**Commonwealth Edison**

September 9, 1982

Subject: Byron Station Units 1 and 2  
Braidwood Station Units 1 and 2  
Waterhammer Prevention  
NRC Docket Nos. 50-454, 50-455,  
50-456 and 50-457

*Figure 1*  
KRSKO

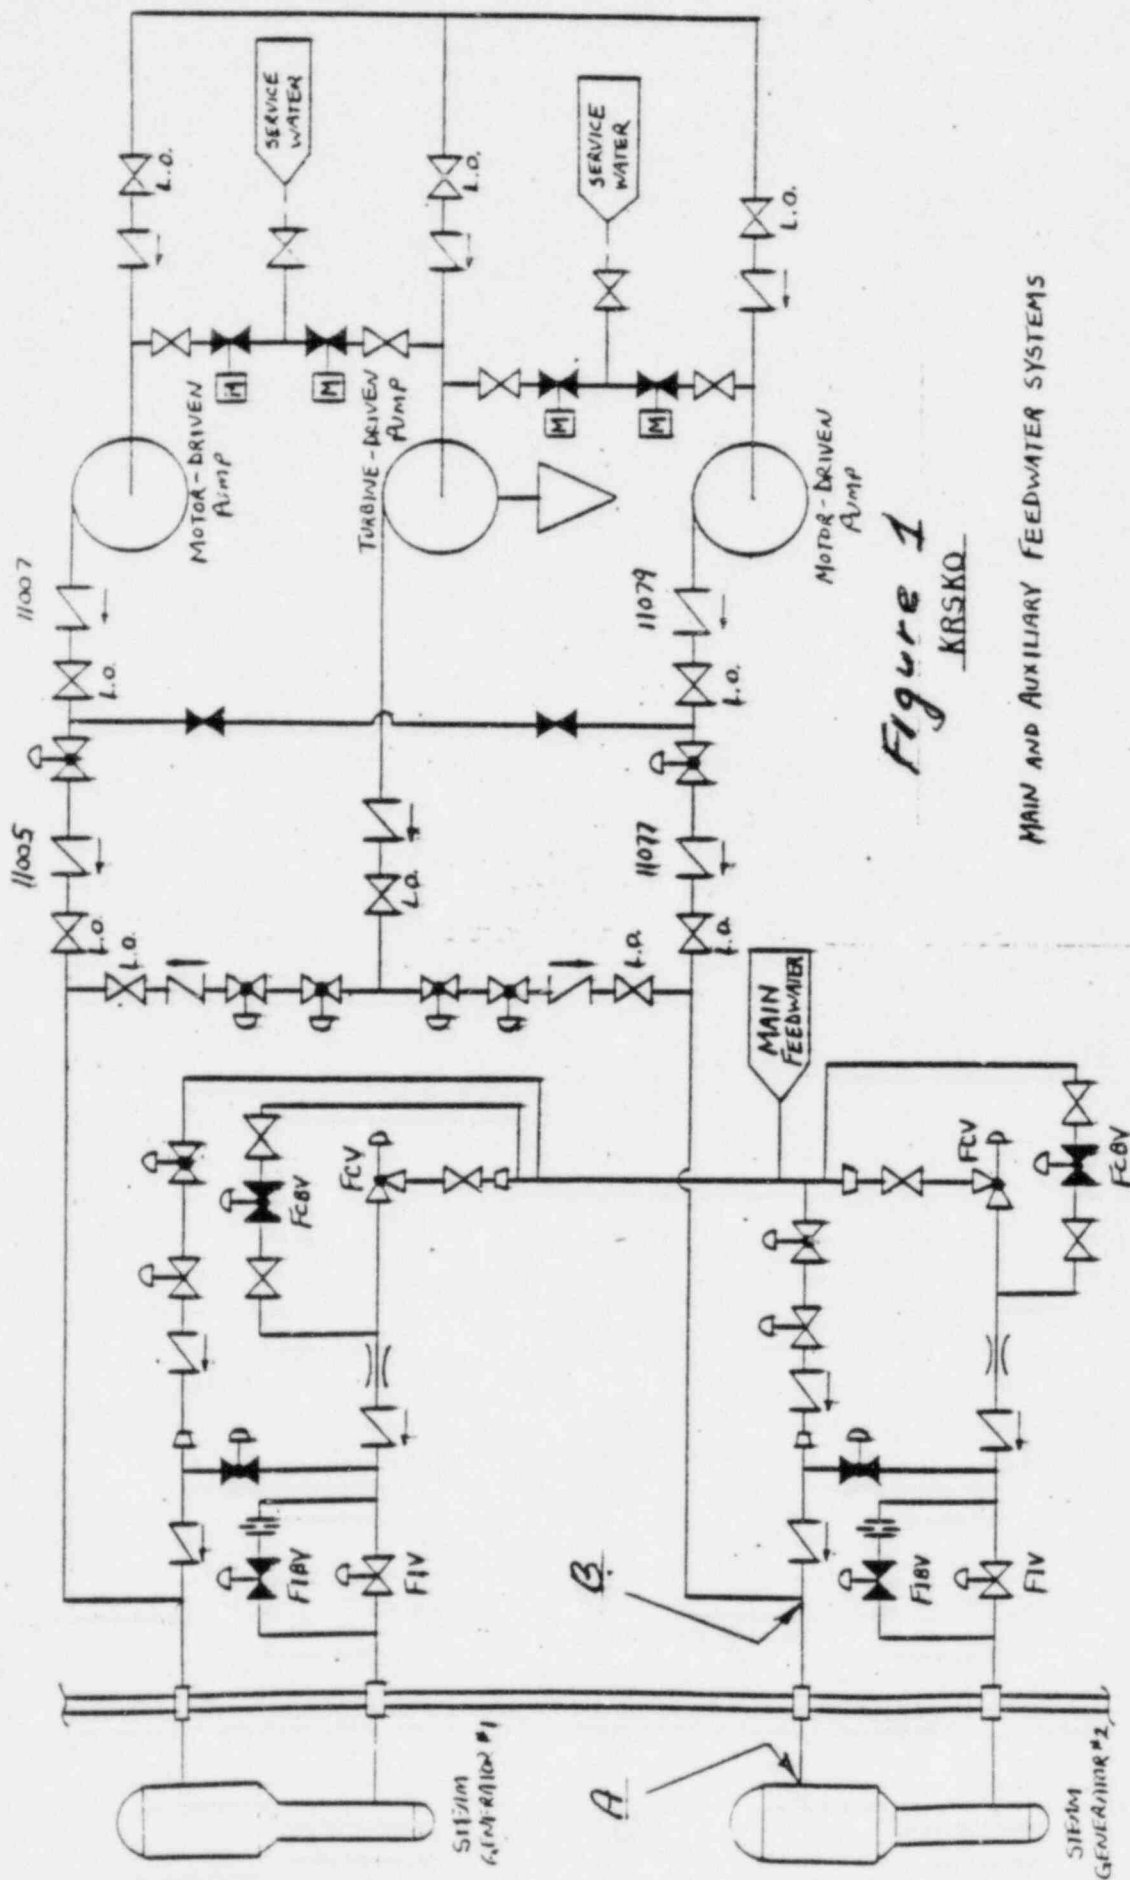
Provide systems design and piping details for the feedwater, auxiliary feedwater, and the feedwater bypass systems for both the Byron and KRSKO plants. This information should be in the form of piping drawings, piping schematics or P&ID's which clearly define piping layouts, valves, and elevations relative to the steam generator feedwater and auxiliary feedwater nozzles. Valves which are controlled from the control room should be identified, along with operation requirements (or procedures) which are at the disposal of the operators.

To reduce the likelihood of backleakage, the Auxiliary Feedwater System check valves which were known to leak, valves 11005, 11007, 11077 and 11079, on Figure 1 were refurbished. The check valves associated with the turbine driven AFS pump discharge were not inspected as a pyrometer check under hot condition indicated no leakage.

The schematic diagram, Figure 1, shows part of the KRSKO plant main feedwater system and auxiliary feedwater system. The diagram includes the feedwater system from the main feedwater header to the steam generator as it was at the time of the waterhammer incident. It has since been modified to permit feeding simultaneously to the main and auxiliary nozzles during high power operation.

As discussed earlier, based on the evidence of blistered and discolored paint, hot water and/or steam leaked back from the steam generators through a section of the six inch Sch 80 bypass piping and then into the AFS. The section of loop 2 bypass piping of interest is indicated in Figure 1 as between Points A and B.

Figure 2, KRSKO

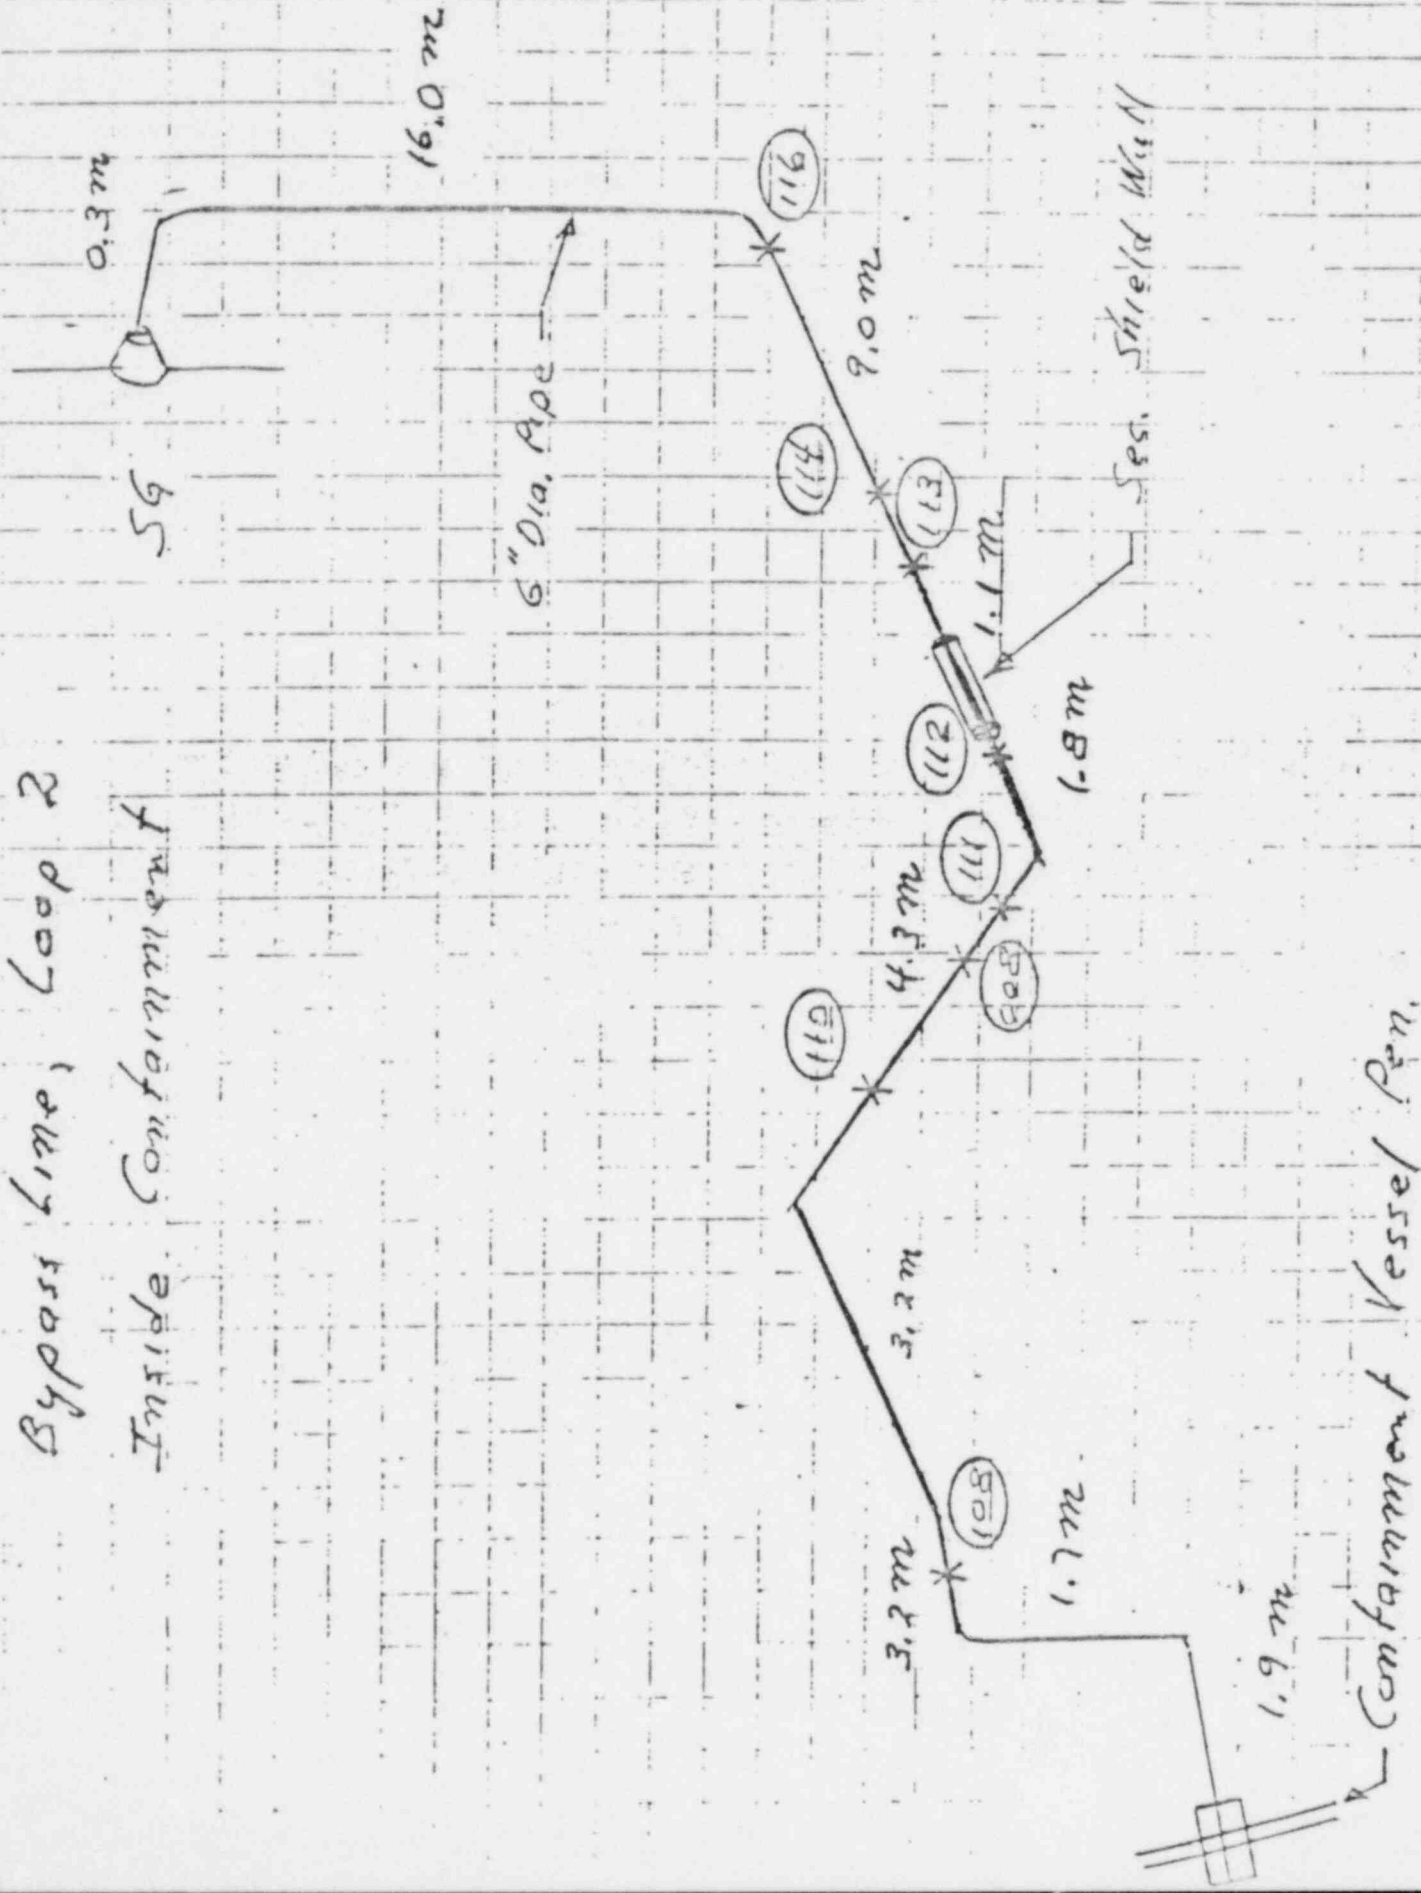
Details of damage discovered in August, 1981, how and when damage was detected, and what evidence (if any) of a water hammer occurring in July, 1981 at the time of stated occurrence.

The extent of the damage to the loop 2 bypass piping inside and outside containment, is presented in Table 1. In Figure 2, the numbers in ovals identify the pipe hangers which were affected. On both Figures 2 and 3, the length in meters of the pipe sections are given. A bulge or blister was observed in the bypass piping, in the horizontal section, downstream of the secondary shield wall, approximately midway between the shield wall and elbow in Figure 2. The bulged region was approximately six to eight inches long, with the bulge located on the top side of the pipe. At the bulge, the pipe diameter was increased approximately one quarter inch.

Two isometric pipe sketches of the bypass piping are presented in Figures 2 and 3. Figure 2 shows the bypass piping inside containment from the six inch auxiliary nozzle to the containment vessel penetration. Figure 3 shows the section of bypass piping from the containment penetration back to the point where the four inch Sch 80 AFS pipe connects.

Fig. 4  
KRSKO 04 59

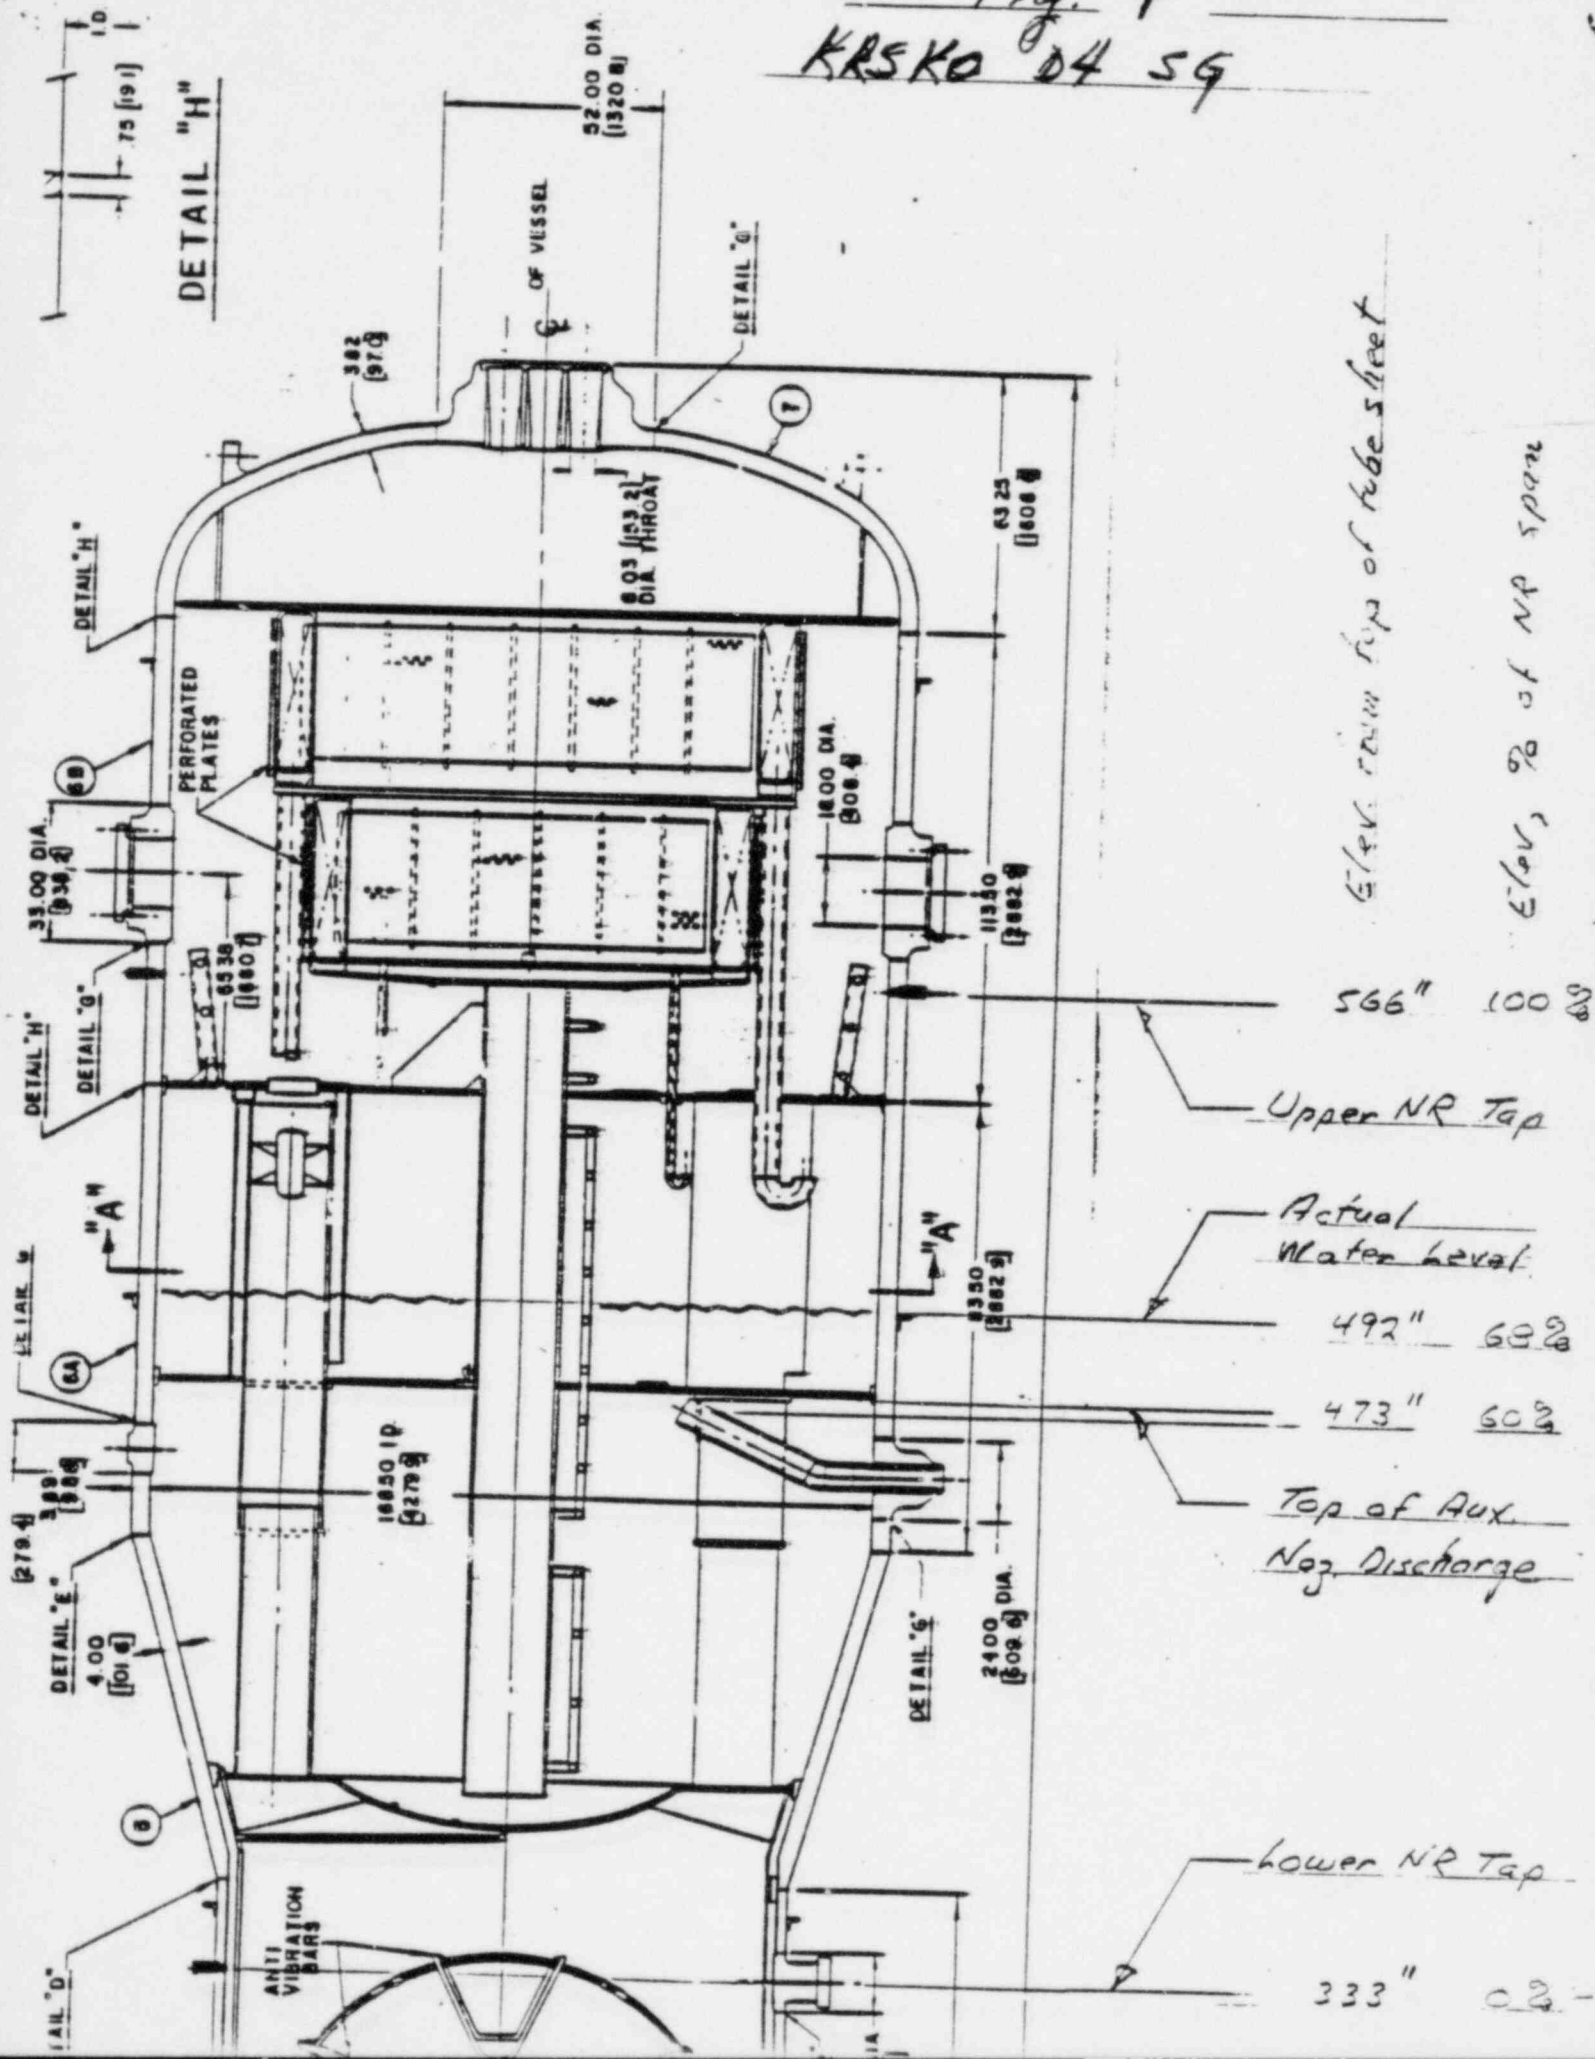
Provide steam generator "internals" design details for both the Byron and KRSKO plants. This information should be in the form of drawing which clearly define Feedwater and Auxiliary Feedwater nozzles, penetrations, flow distributors, etc. This information will be used to determine similarities and differences between the proposed Byron Steam Generators and KRSKO Steam Generators.

The internals of the KRSKO Model D4 steam generator are shown in Figures 4 and 5. Figure 4 for the upper shell shows the auxiliary nozzle and internal extension. Also indicated is the actual water level for 100 percent power.
